PROPOSED IMPROVEMENT TOWNS OF RUTLAND/MENDON/ KILLINGTON COUNTY OF RUTLAND U.S. ROUTE 4

BEGINNING AT THE CITY OF RUTLAND / RUTLAND TOWN LINE AT
MILE MARKER 0.000 = STA. 0+000.000 AND EXTENDING EASTERLY ALONG U.S. ROUTE 4 FOR A
DISTANCE OF 15 929.287 m (9.898 MILES) TO A POINT IN KILLINGTON AT MILE MARKER 2.728 = STA. 4+390.290.

RECORD PLANS

PAVING
DETAILS AND
PAVEMENT
JOINT DETAIL
SHEET

SHOULDER
RECONSTRUCTION
DETAIL
SHEET

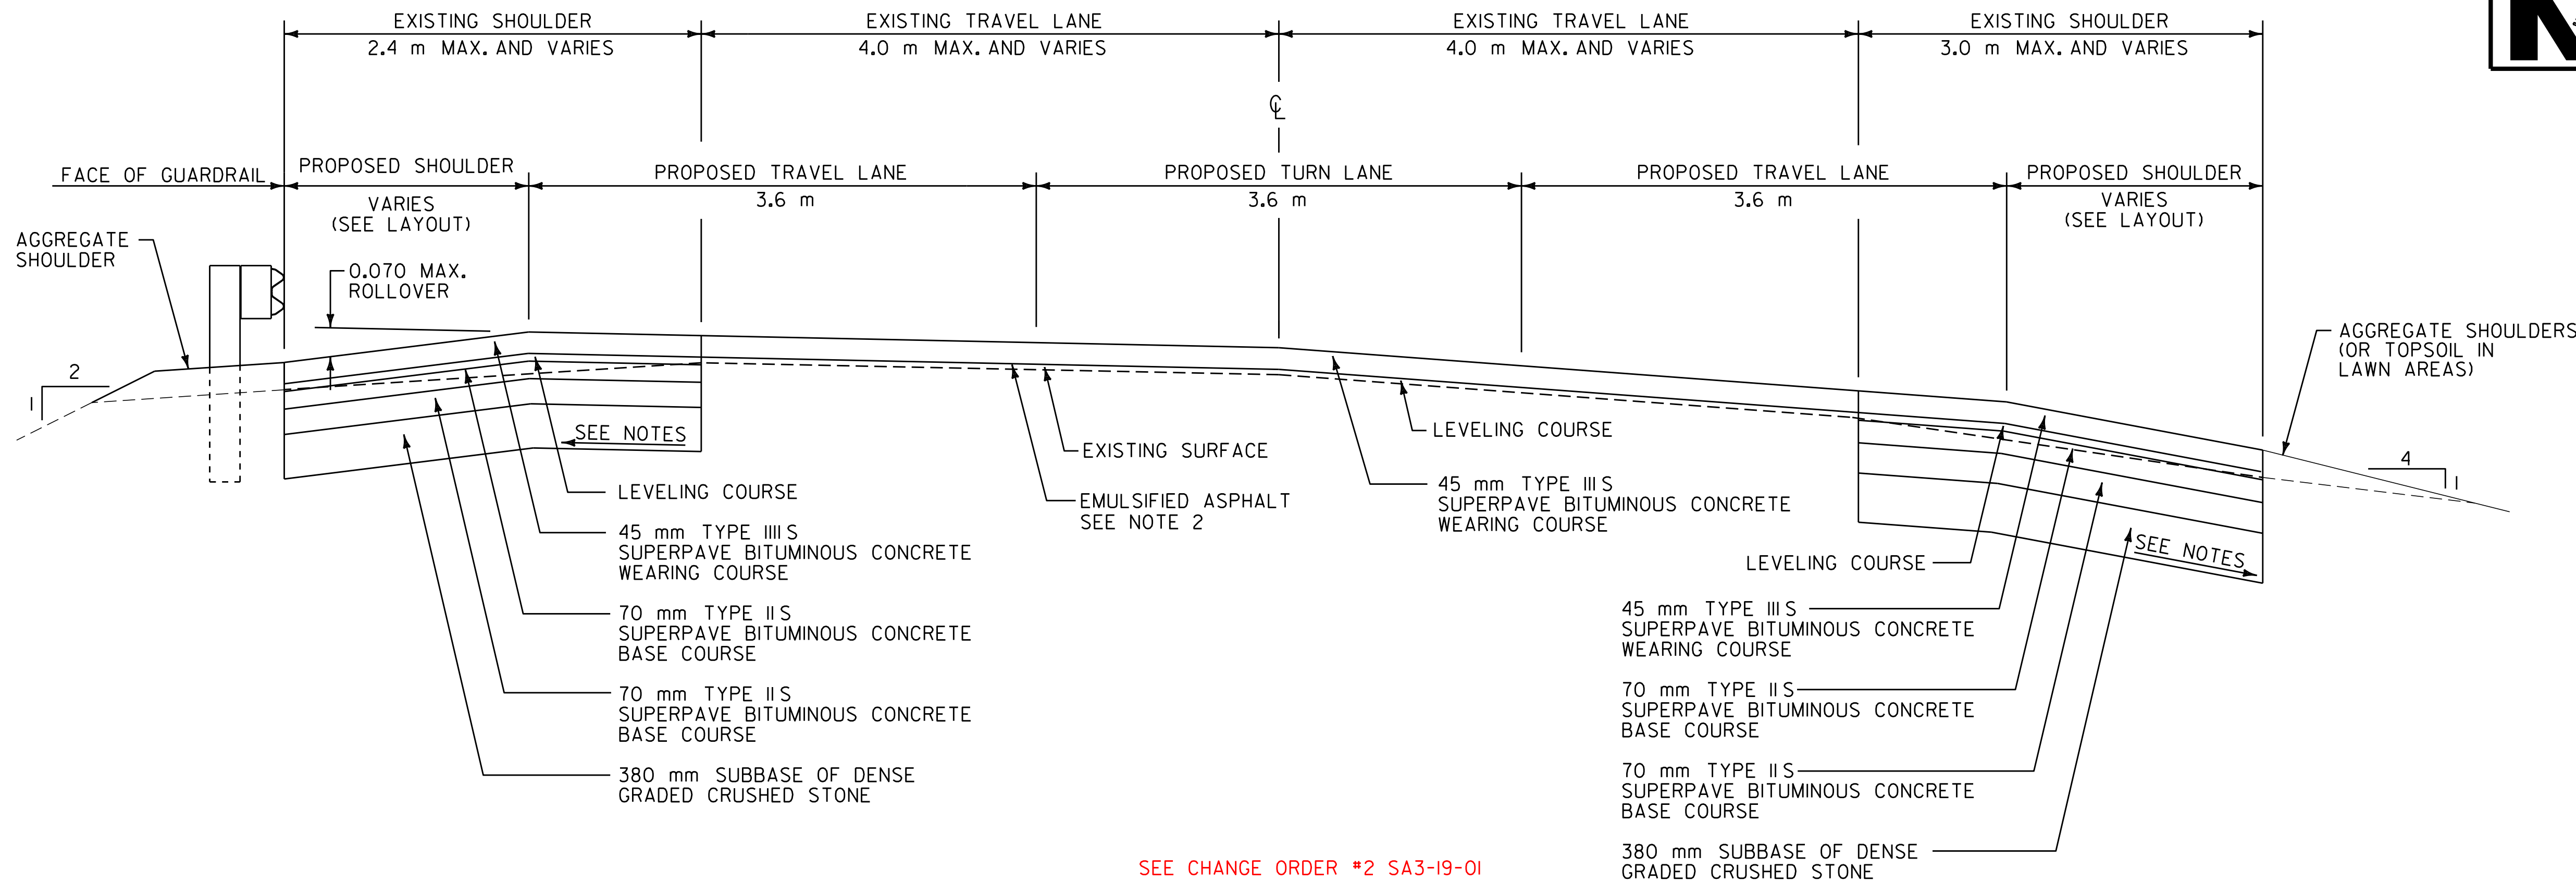
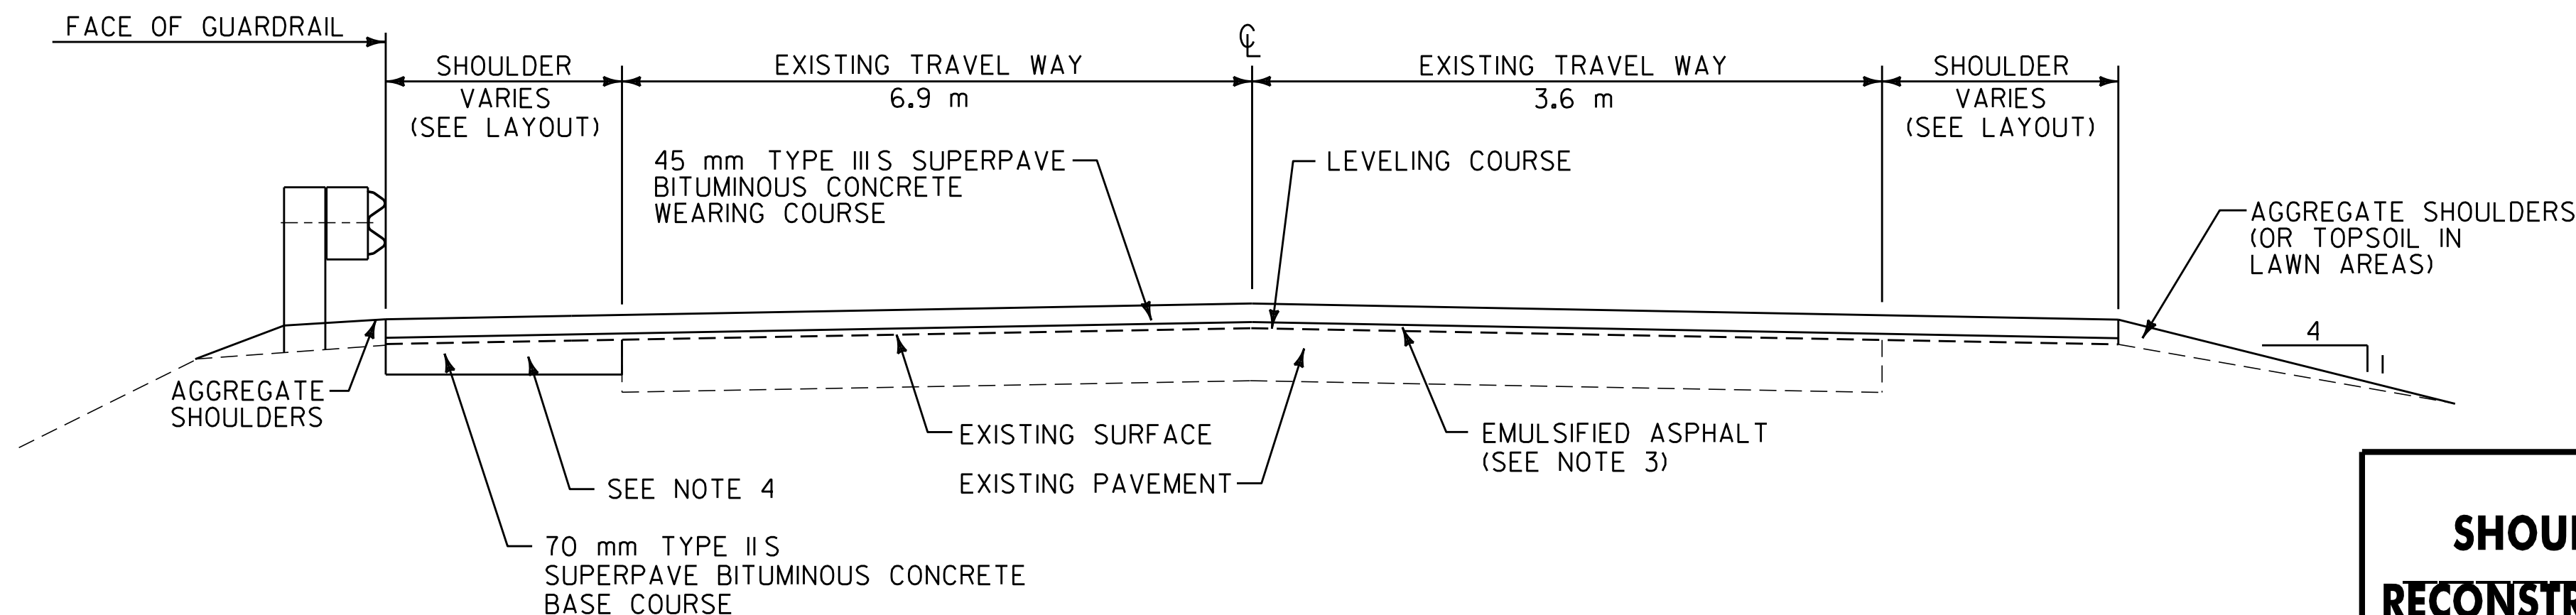
SEE CHANGE ORDER #2 SA3-I9-01
~~ELIMINATED -SHOULDER RECONSTRUCTION DETAIL #1~~
